Addendum 33 – Regulation No. 34

Revision 1 – Amendment 3

Supplement 3 to the 02 series of amendments: Date of entry into force: 24 October 2009

**UNIFORM PROVISIONS CONCERNING THE APPROVAL OF VEHICLES WITH
REGARD TO THE PREVENTION OF FIRE RISKS**

"Model C
(see paragraph 3.2.4. of this Regulation)

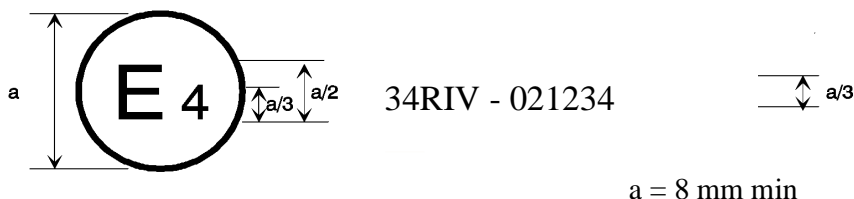
Insert new models C, D and E, to read:

The above approval mark affixed to a fuel tank shows that the type concerned was approved in the Netherlands (E4) pursuant to Part III of Regulation No. 34, for a universal use including its accessories, under approval No. 021234. The first two digits (02) of the approval number indicate that the approval was granted in accordance with the requirements of Regulation No. 34 as amended by the 02 series of amendments.

Model D
 (see paragraph 3.3.4. of this Regulation)

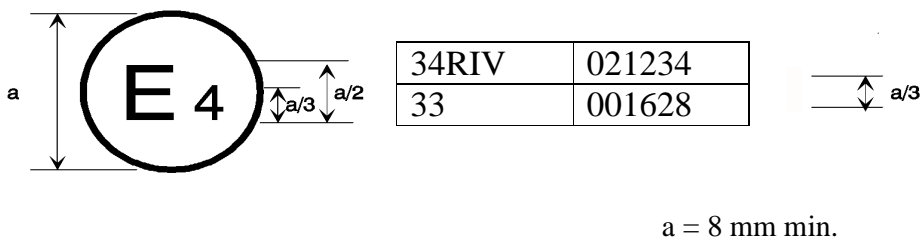
The above approval mark affixed to a vehicle shows that the type concerned was approved in the Netherlands (E4) pursuant to Part IV of Regulation No. 34 under approval No. 021234. The first two digits (02) of the approval number indicate that the approval was granted in accordance with the requirements of Regulation No. 34 as amended by the 02 series of amendments.
